San Francisco Arts Commission Civic Design Review

PROJECT TITLE 17th & Folsom Park DATE 02/04/13

Civic Design Review
Phase 2
February 2013

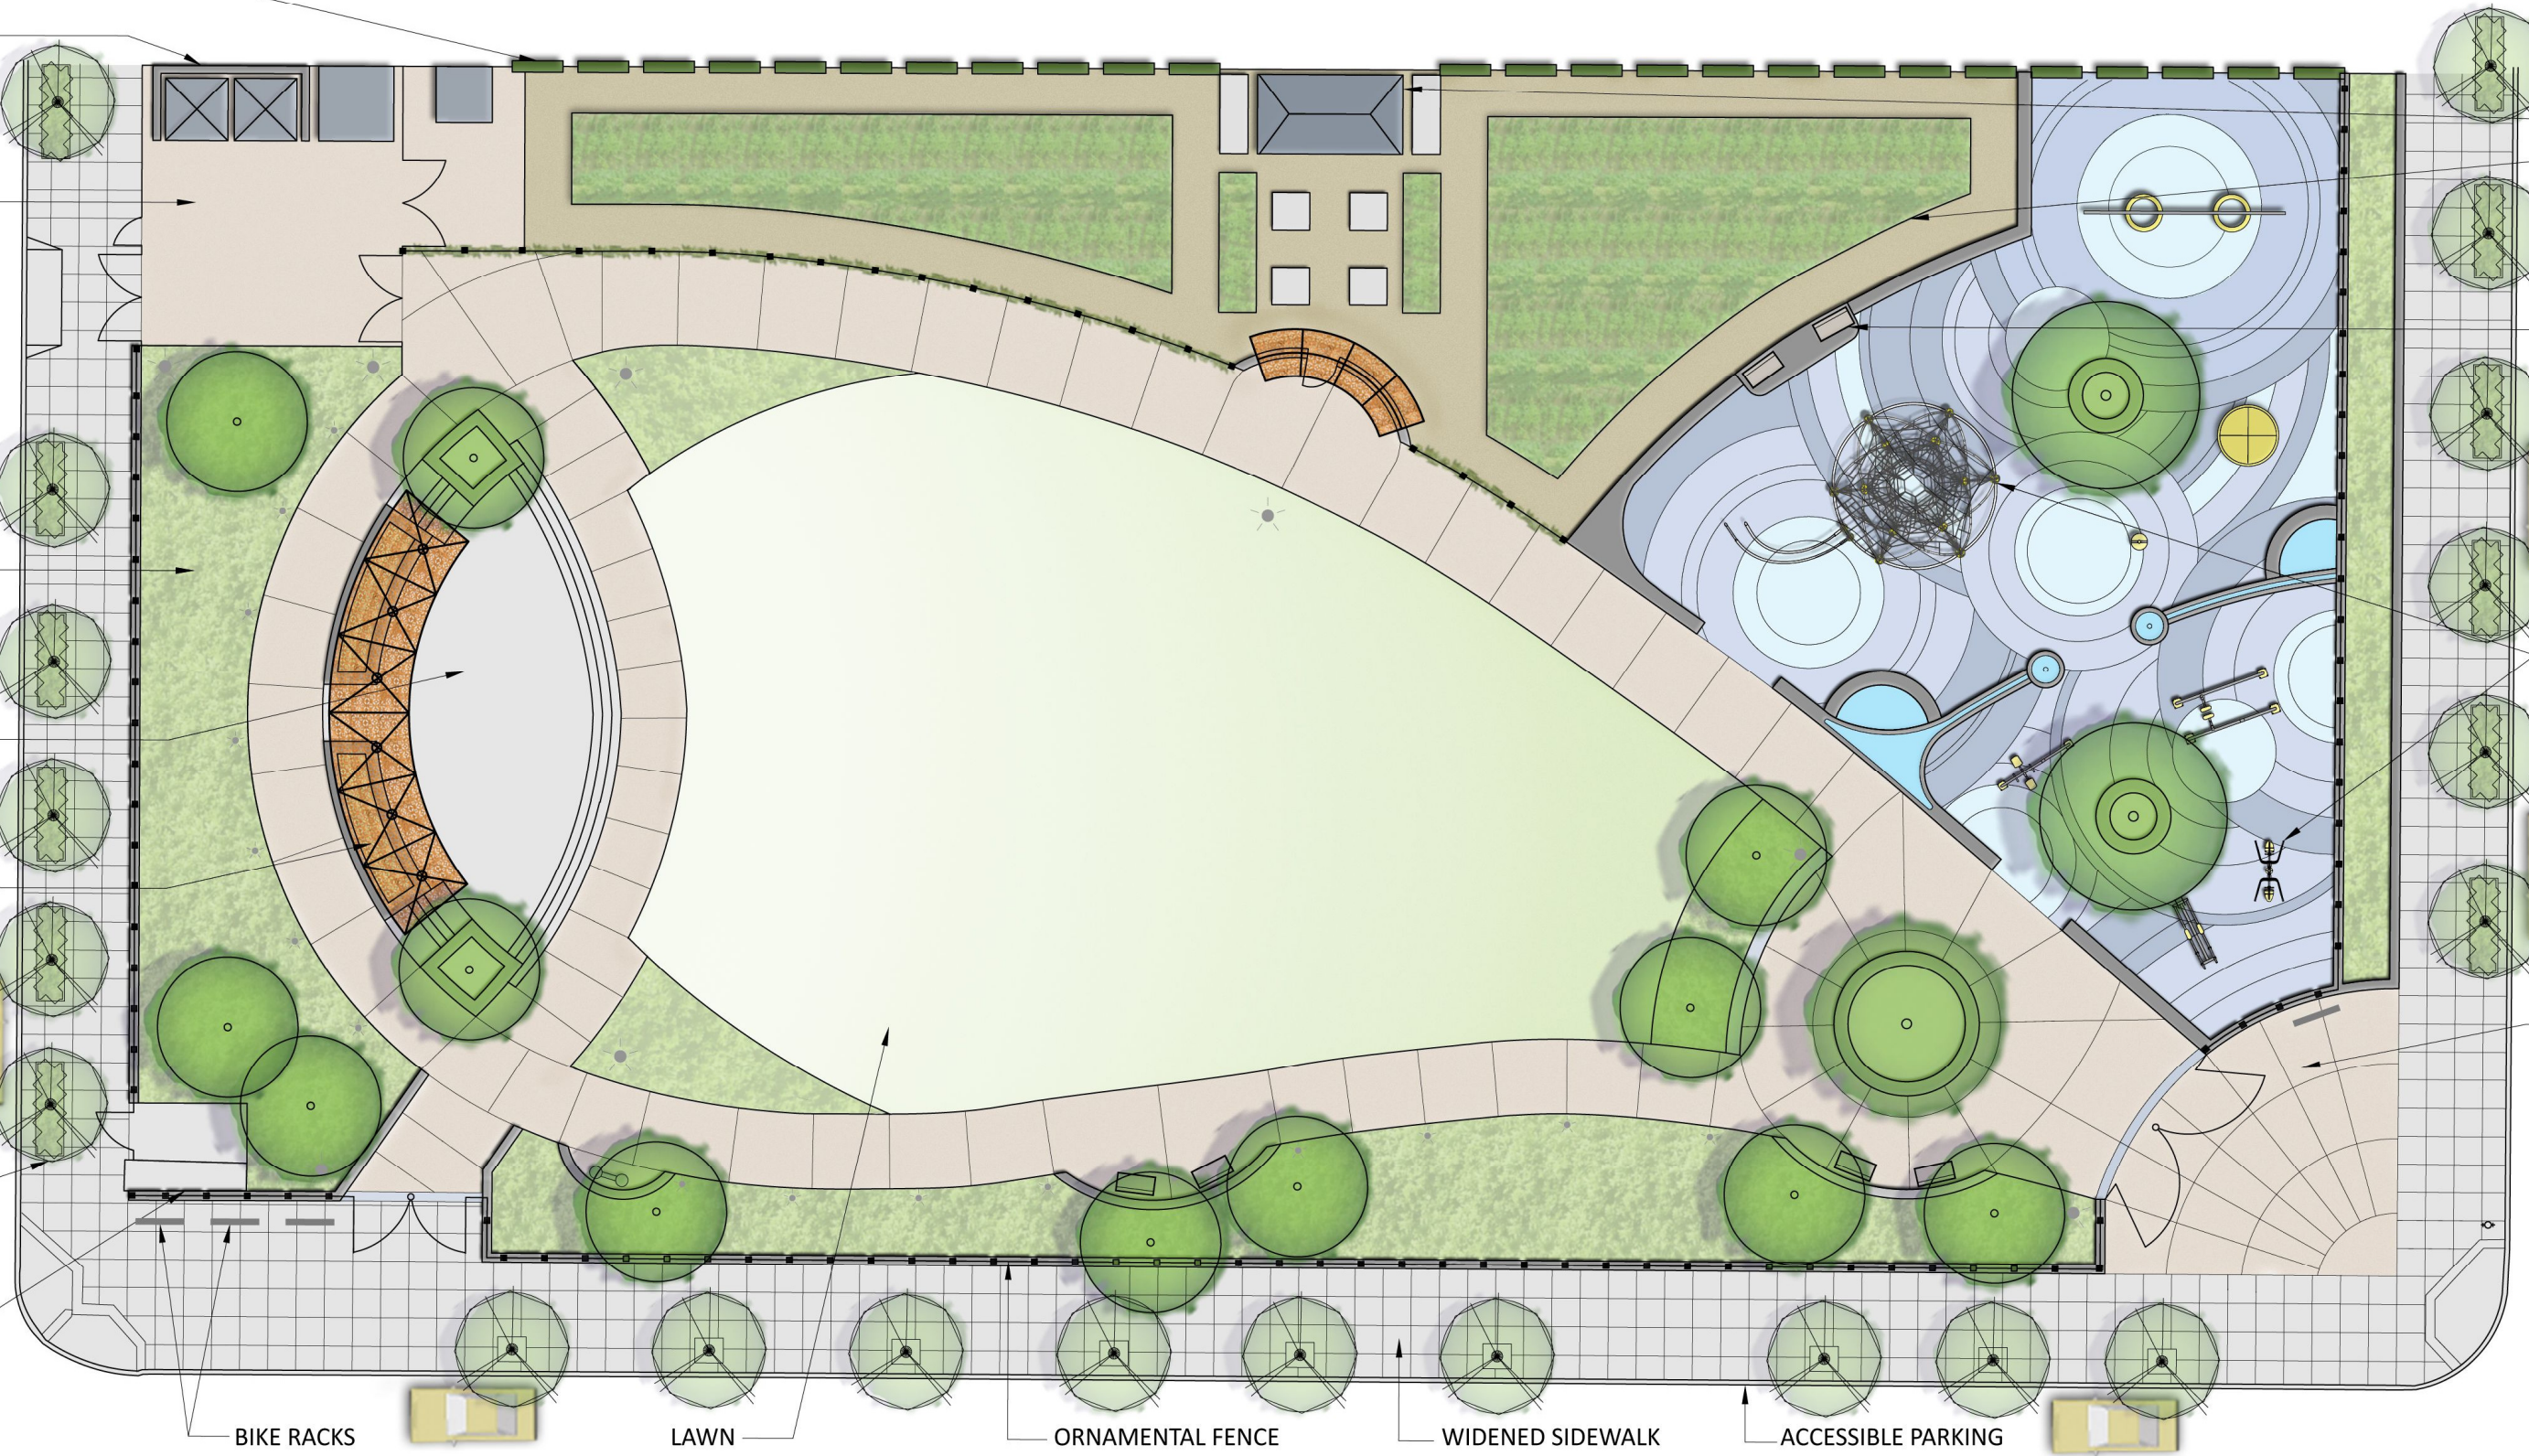
- Minimize convergence of major path to service yard gates.
- Relate circular pattern in play area to play equipment and tree.
- Separate two paths divided by the community garden fence with seating or planting. Consider removing fence.
- Consider additional seating, conversation nooks, cut outs to promote interaction in the park.
- Forms inside park should be curving/bulbous/amorphous. Forms outside on the frame should be rectilinear.
- Use planting or paths to distinguish spaces.
- Community garden rows should free themselves of the frame.
- Provide topography for the lawn.
- Paths should not have parallel sides.
